**Town of Surfside
DESIGN REVIEW BOARD/
PLANNING & ZONING BOARD
AGENDA**

Subject: 8995 Collins Avenue
From: Guillermo Olmedillo, Town Manager
Sarah Sinatra Gould, AICP, Town Planner

Comments Based on Plan Submittal: 2nd submittal (revised plan)

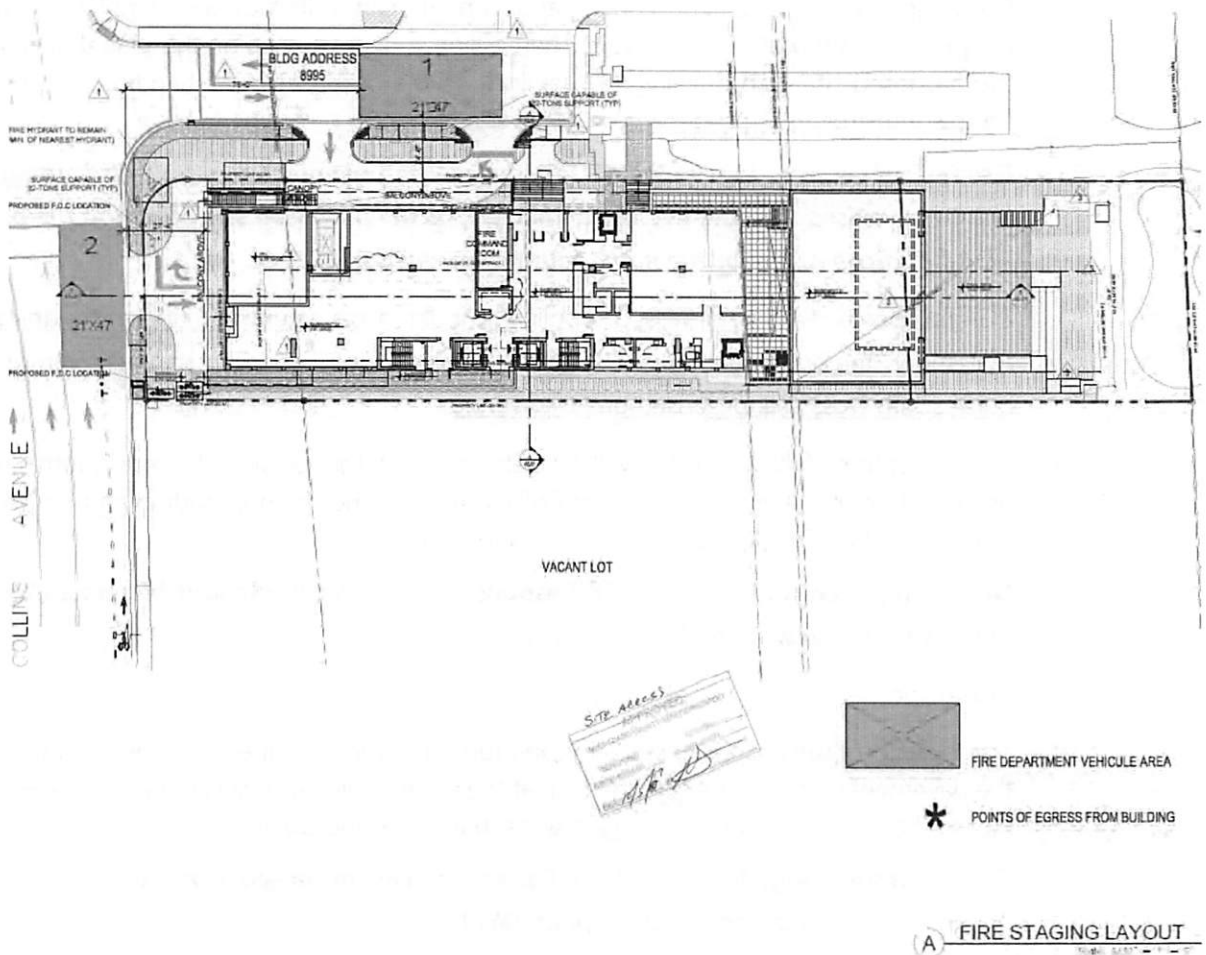
7. Please either label the directional arrows that are shown on the pavement marking and signage plan as "informational only" or remove the symbols from the plans. It is unclear from the design plans if these are to be installed as part of the project.

Ocean Engineering, Inc. 04/23/18 Response: *the directional arrows have been removed from the pavement marking and signage plan. (WL)*

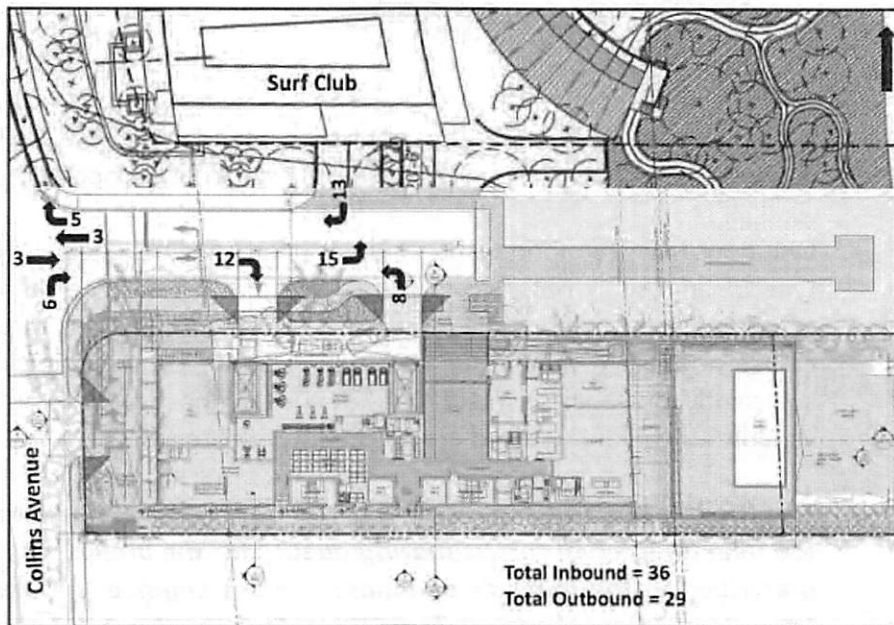
- One hour is far too long to be an appropriate analysis interval. The result of this type of analysis is sensitive to the choice of analysis "interval" length. For any sufficiently short interval the most likely number of arrivals is zero and there is of course no chance of any queue. In undersaturated conditions like this, given a sufficiently long analysis interval, any queue buildups within the interval due to the variable arrival rate involved are inevitably discharged.

Tom Hall 04/23/18 Response: *While the reviewer may believe an hour to be too long an interval for estimating queues for the project, that is the method prescribed in the Institute of Transportation Engineer's Transportation and Land Development manual. In an effort to think through another method for considering the random arrival of vehicles to form a queue of entering vehicles, it occurred to us that Simtraffic could provide such an estimate. As a microscopic simulation model, it looks at every vehicle on a random arrival basis.*

CONFLICT POINTS DIAGRAM

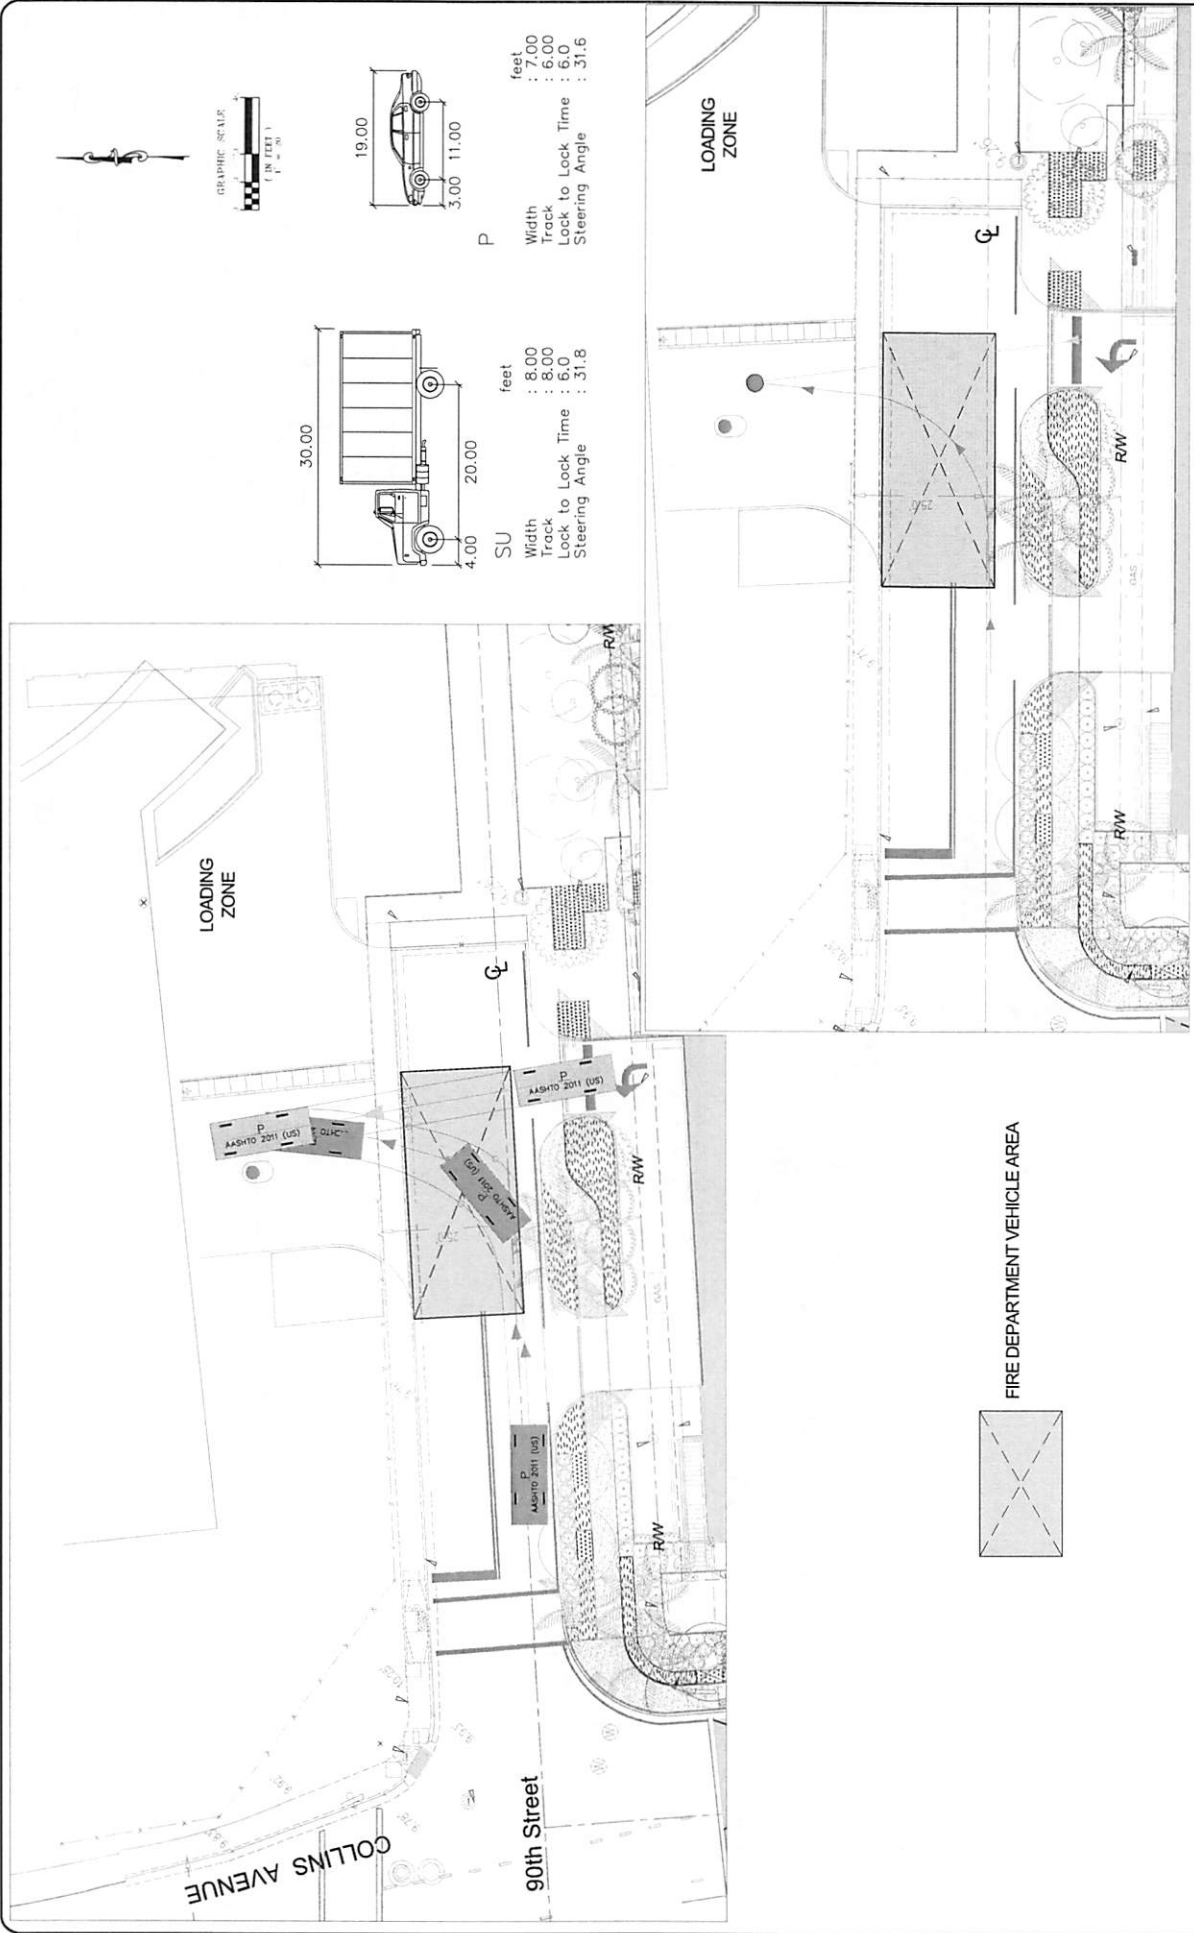
To demonstrate the concerns, staff prepared the attached Conflict Point Drawing which shows the number of conflicts that could potentially occur within the 90th Street public right of way. Subsets of the overall Conflict Point Drawing were created that show all of the individual movements. This graphic also includes the Fire Rescue laddering area.
